# Maintenance Task Group Electronic Meeting

March 29, 2022

# Maintenance Request #0314

**Figure 90-5—Data delay measurement**

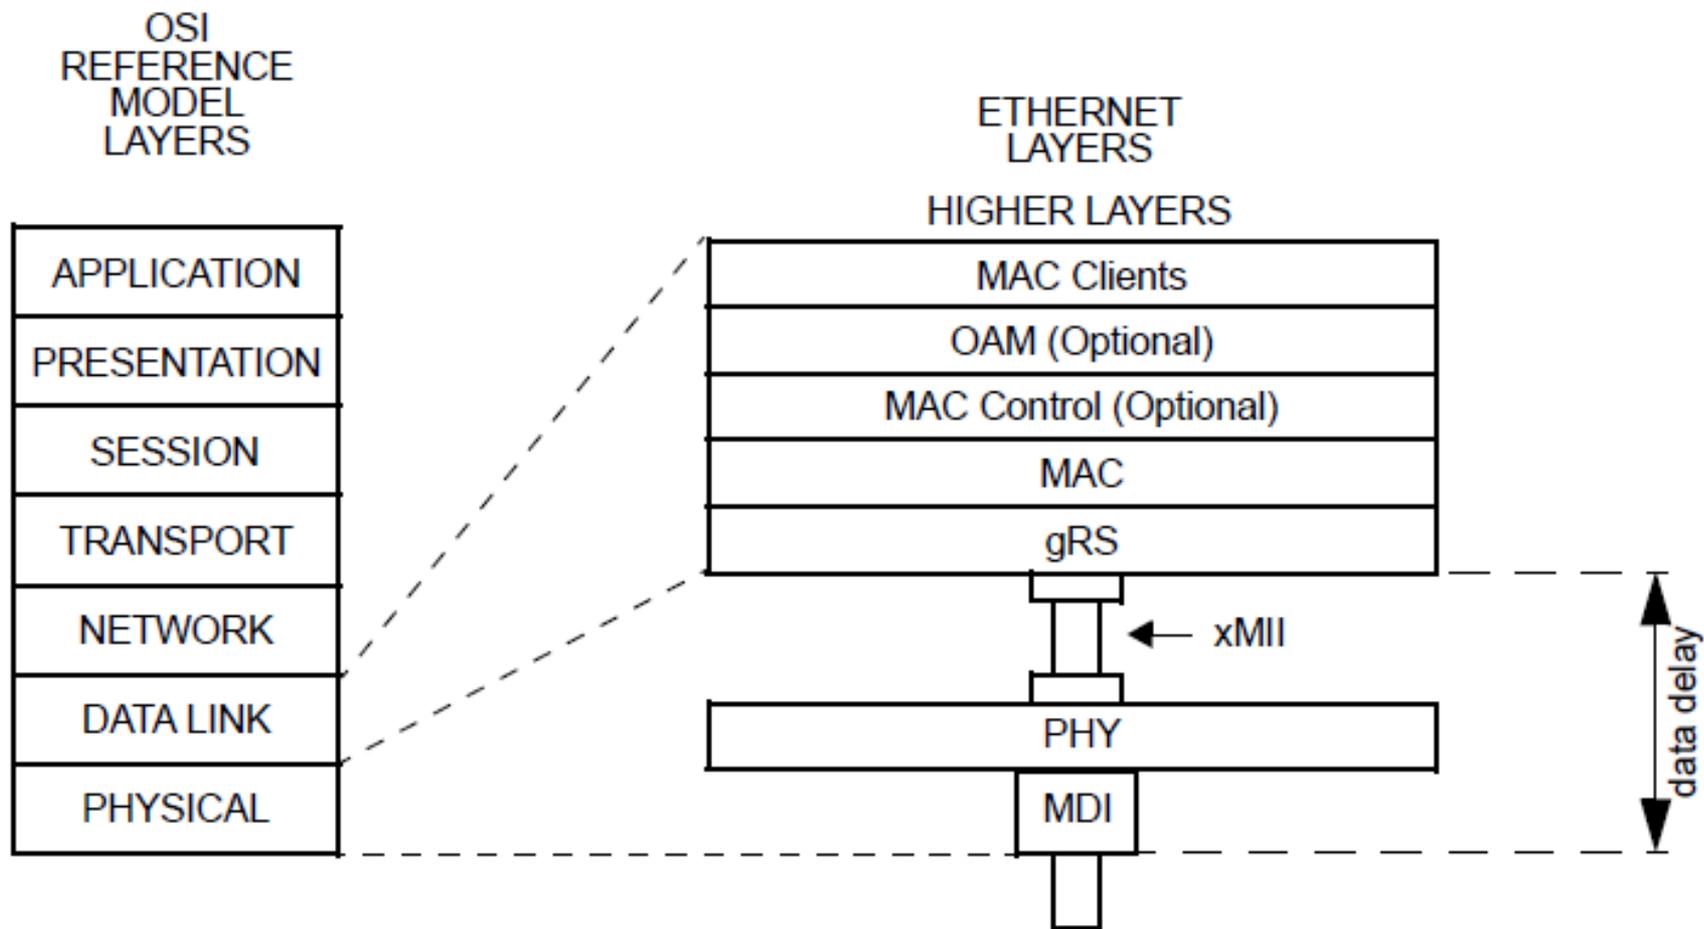
- [0314](#): network media and PHY
- The text "boundary between the network media and PHY" is problematic due to terminology/abbreviation usage in the context of 802.1Q. This text is found at various locations throughout the standard (16 matches in D0.2 of the next Q-Rev).
- We recommend to describe a specific reference point within other standards (e.g. 802.3) for the point between the medium and the PHY.
- Recommended to define a reference point in 802.1AC and have each MAC specify how to identify it. 802.1Q would use the 802.1AC reference point where appropriate.
- P802.3cx is defining a reference point at the MII that could be used as a good example for this purpose.
- Recommended to review the 802.3cx document and determine if this is a good example for a reference point and any proposed text changes to AC.
